HALLS MILL CREEK SUBDIVISION, **RESUBDIVISION OF LOTS 7 & 8**

APPLICATION NUMBER 4 DATE October 6, 2005

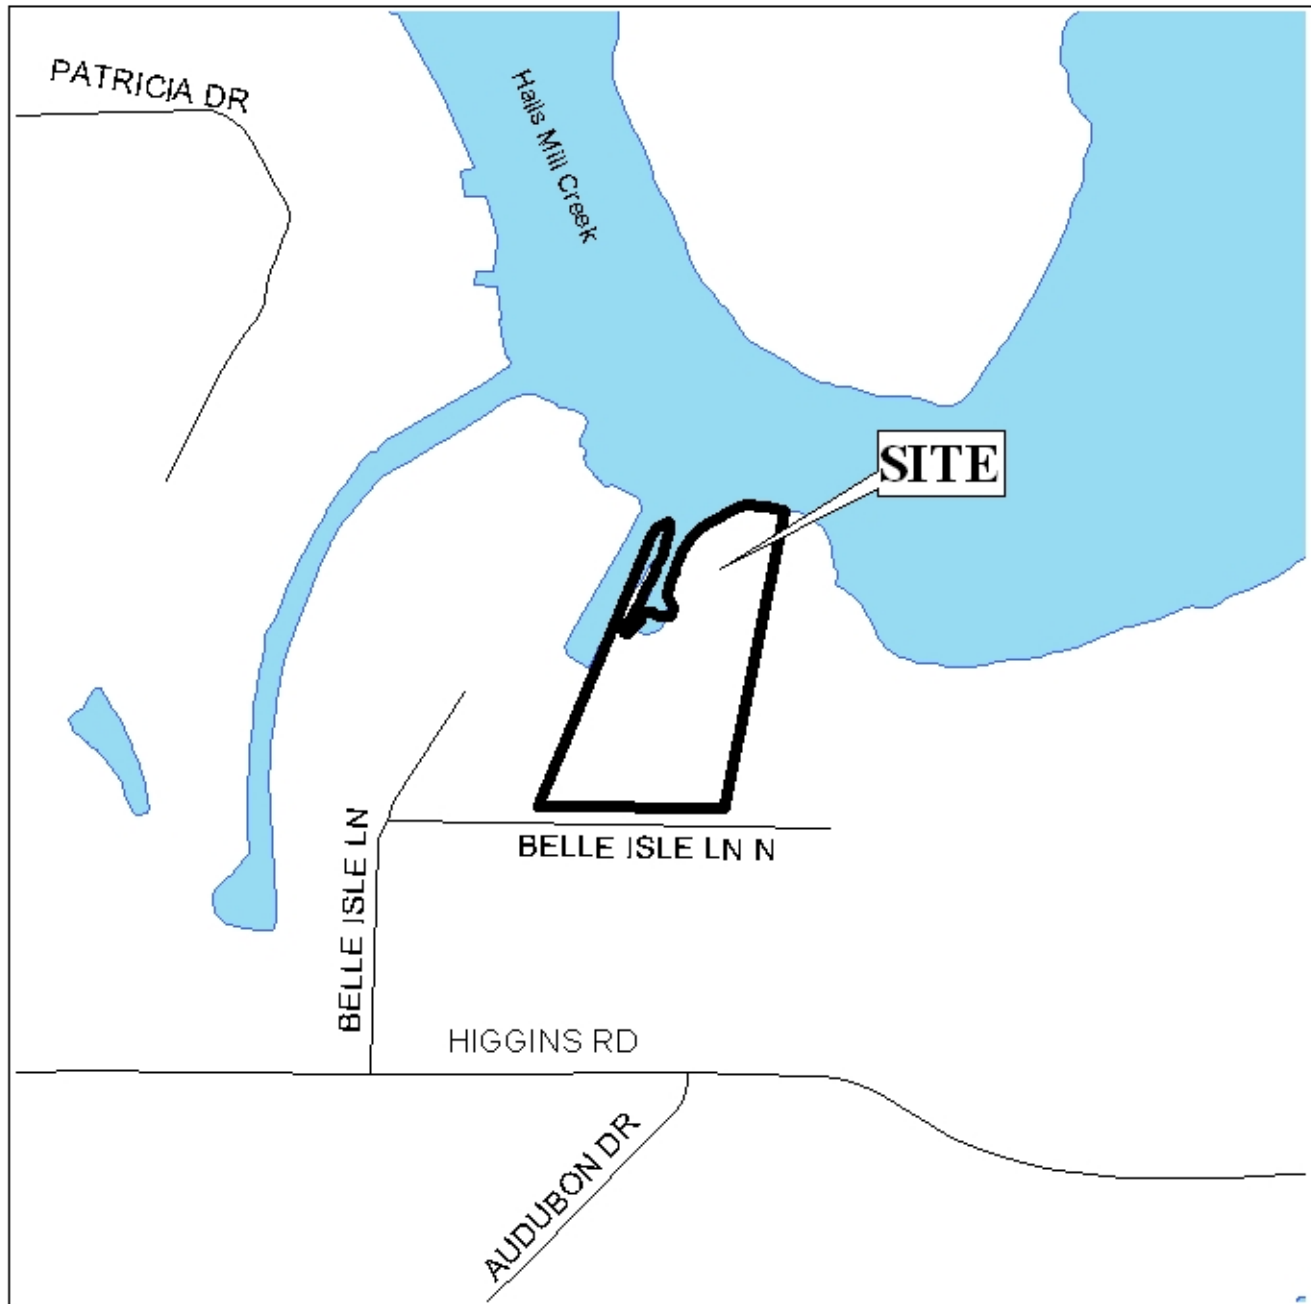
The plat illustrates the proposed 2 lot, 2.5 \pm acres subdivision which is located on the North side of Belle Isle Lane North, 200' \pm East of Belle Isle Lane and is in City Council District 4. The subdivision is served by public water and sanitary sewer.

The purpose of this application is to shift an interior lot line.

The site is accessed by Belle Isle Lane North, which is a gravel road. Normally, it is the practice of the Planning Commission to deny applications that will access a substandard roadway. However, the lots for this site already exist and there will be no further increase in the number of lots to the roadway.

As the site is located on Halls Mill Creek, the area may be environmentally sensitive; therefore, the approval of all applicable federal, state and local agencies would be required prior to the issuance of any permits.

The site exceeds the maximum width to depth ratio as recommended by the Subdivision Regulations; therefore, a waiver of Section V.D.3., would be required. However, narrow, deep lots are typical along waterways; thus a waiver of V.D.3. would be appropriate.

With modifications and a waiver of Section V.D.3. (width to depth ratio), the plat will meet the minimum requirements of the Subdivision Regulations and is recommended for Tentative Approval subject to the following condition: 1) the approval of all applicable federal, state and local agencies prior to the issuance of any permits.
